## PLANNING & ZONING COMMISSION AGENDA

**Subject: Development Clearing Permit – Brighthouse Learning 21464 Clear Creek Drive**

**Subject: Variance 101 Abita Oaks Blvd**

# 21464 Clear Creek Landscape Plan

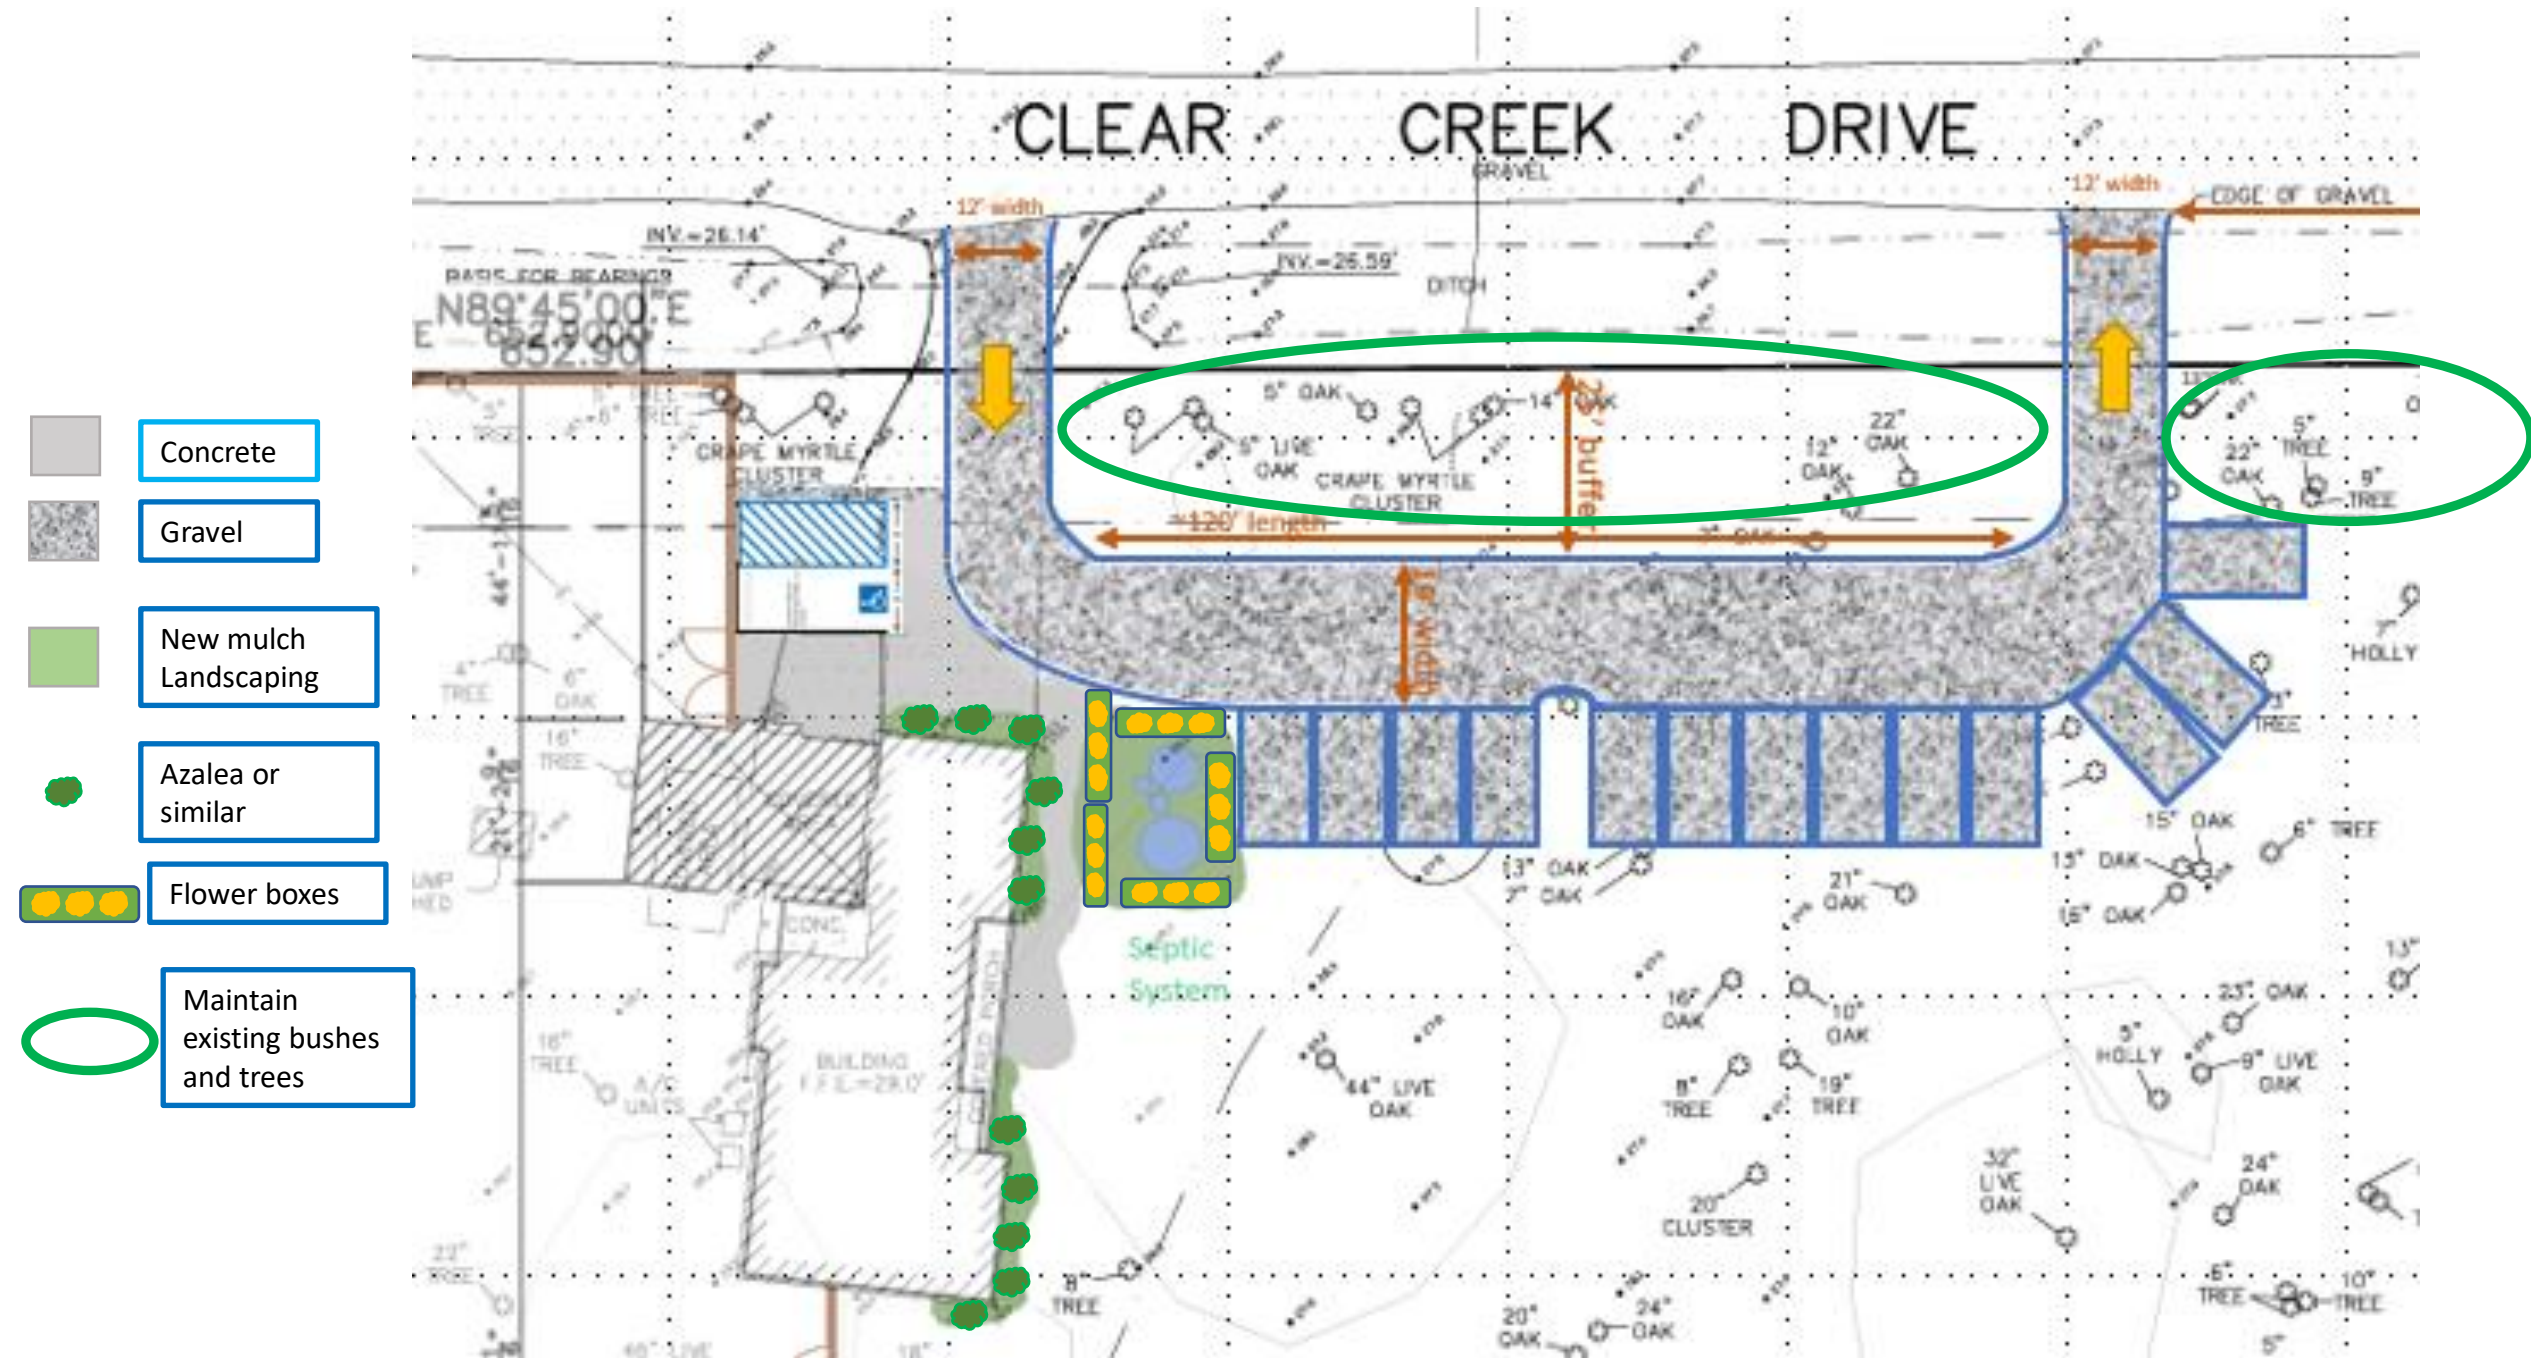
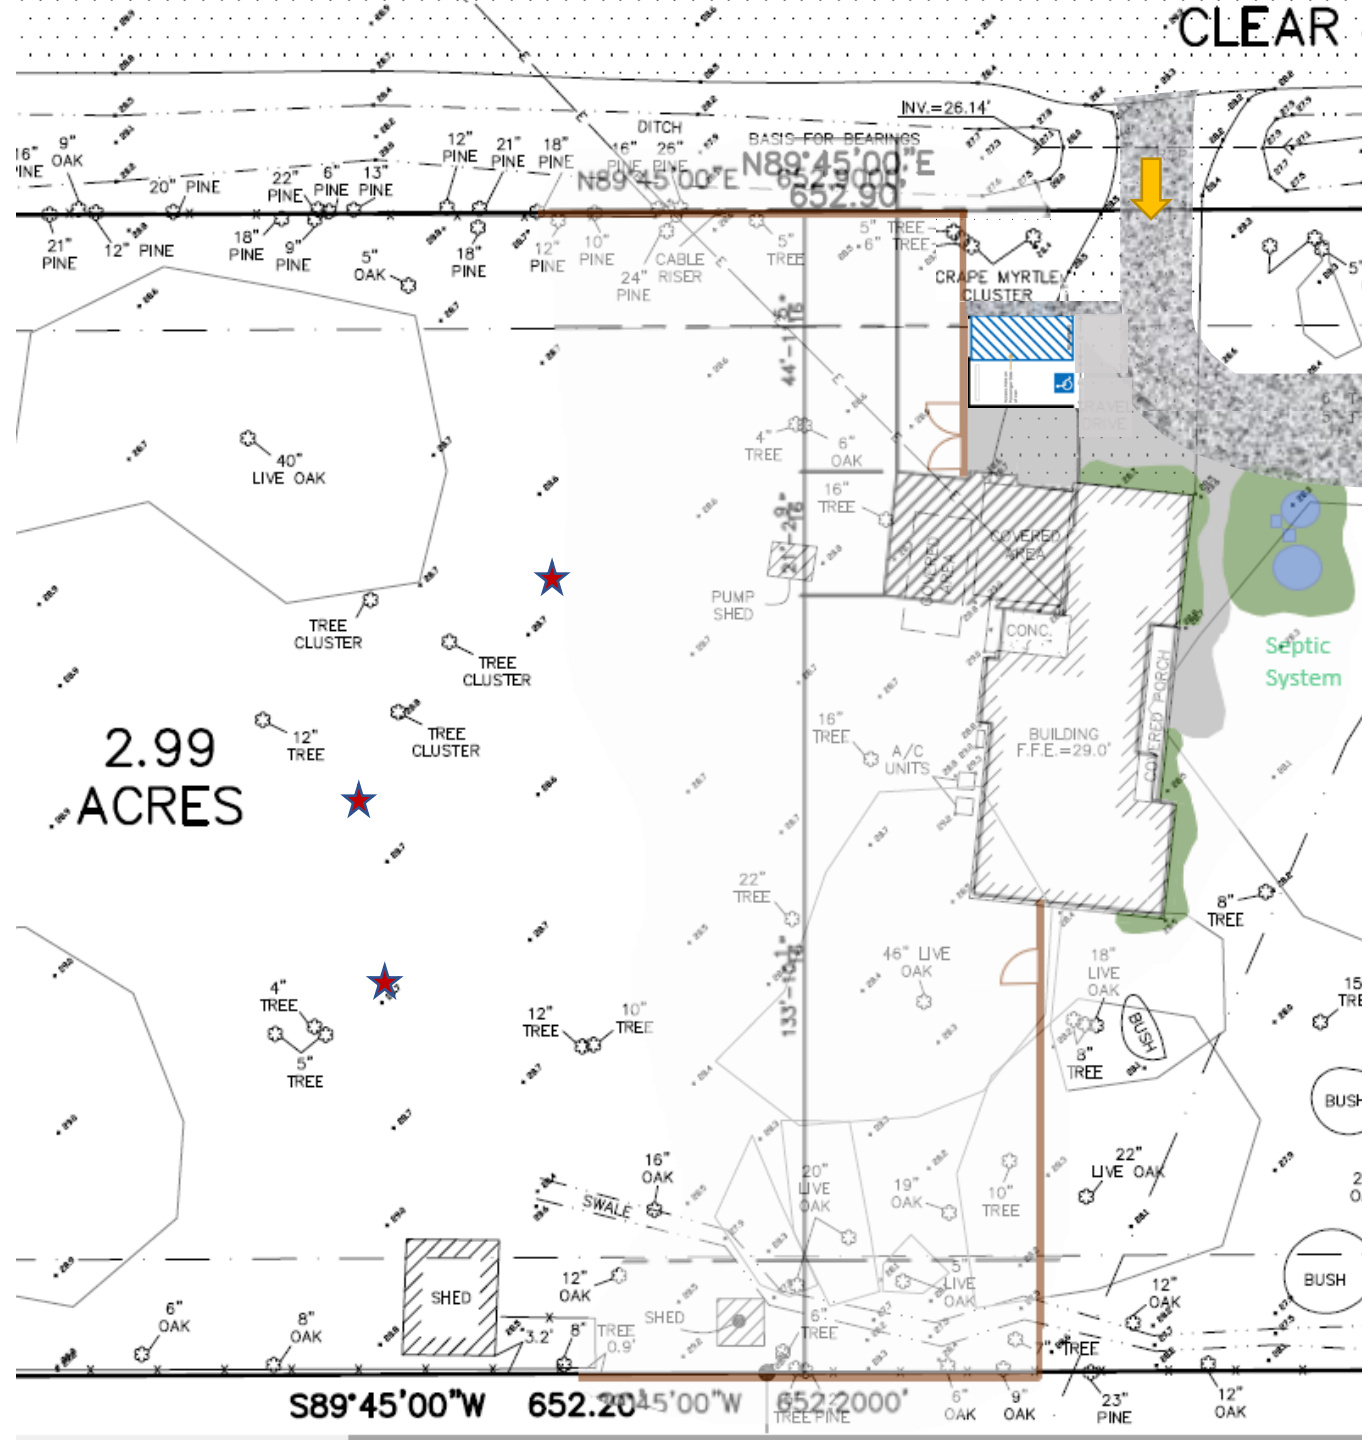
The applicants have submitted the landscape plan required under criterion (3). The landscape plan shows buffer areas, flower boxes, and shrubs to be planted. The plan also shows that three (3) swamp maples would be planted in the rear yard of the property. Section 9-707 does not specify any requirements or review standards for landscape plans. Dr. Malcolm Guidry, Town Arborist, reviewed the landscape plan at the request of staff and found that the plan was acceptable.

The 25-foot roadway buffer shown in the landscape plan meets the buffer requirement of criterion (4)a.

As shown in the applicants' landscape plan, three (3) swamp maples would be planted in the rear yard of the property. This planting meets the requirement of Sec. 9-708 (g).

# 21464 Clear Creek Drainage Plan

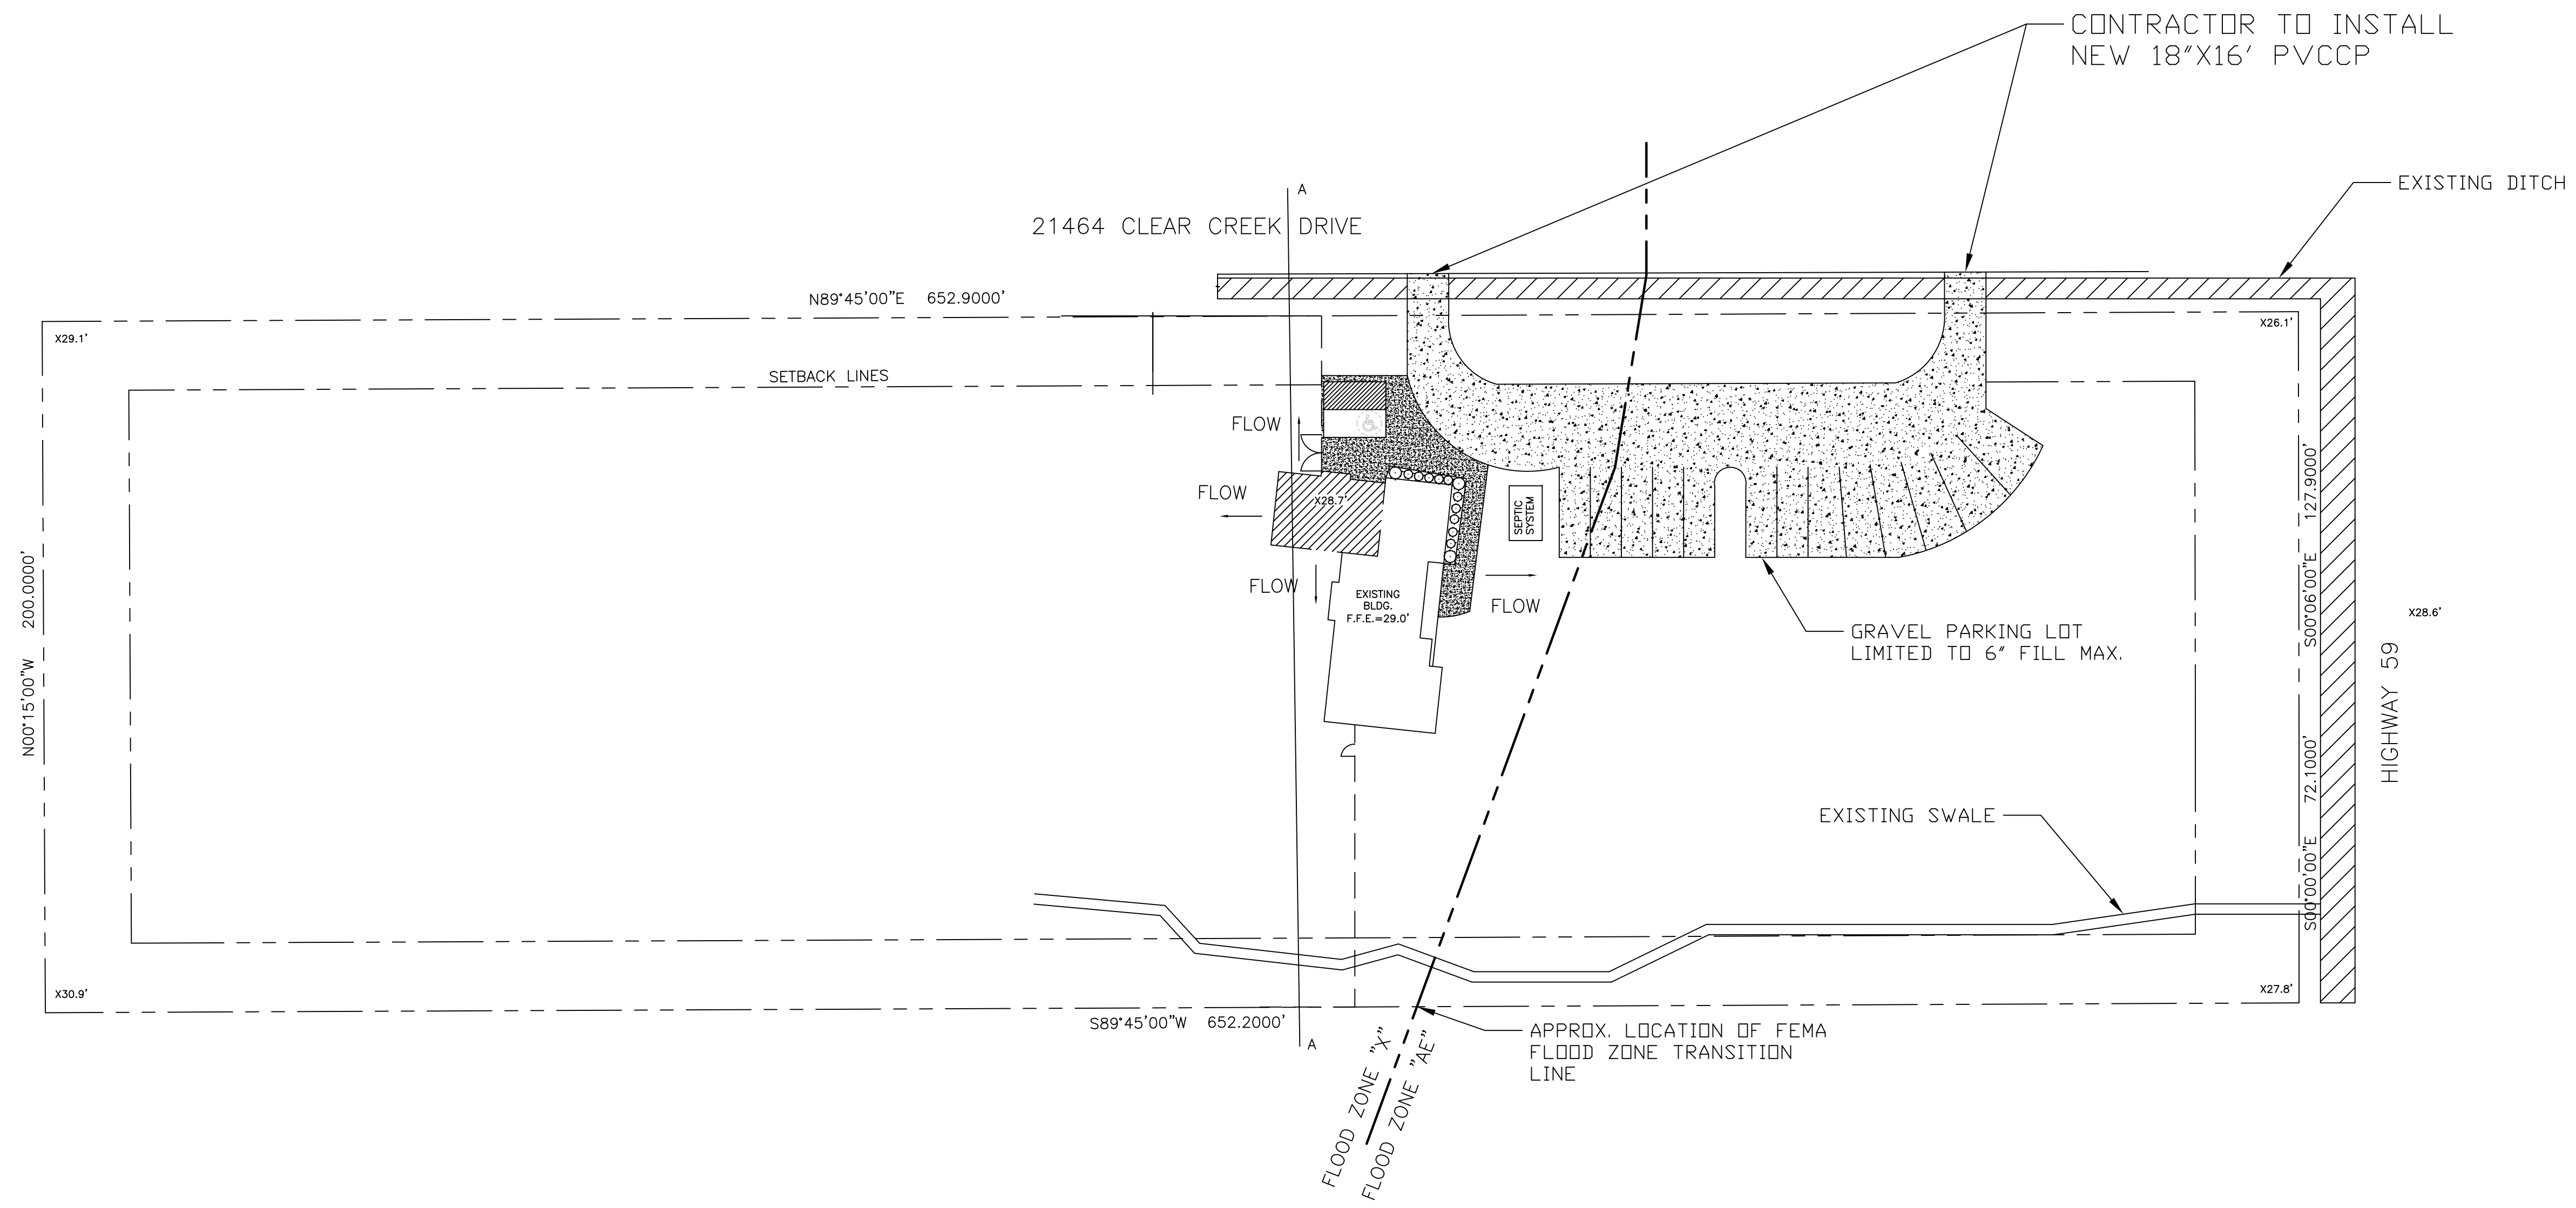
The erosion and sediment control plan included as part of the tree removal plan and the drainage plan have been reviewed by the Town's drainage consultant. The drainage consultant has approved the drainage plan and specified areas where silt fence barriers are required.

**DRAINAGE PLAN "CONDITIONAL" APPROVAL:**
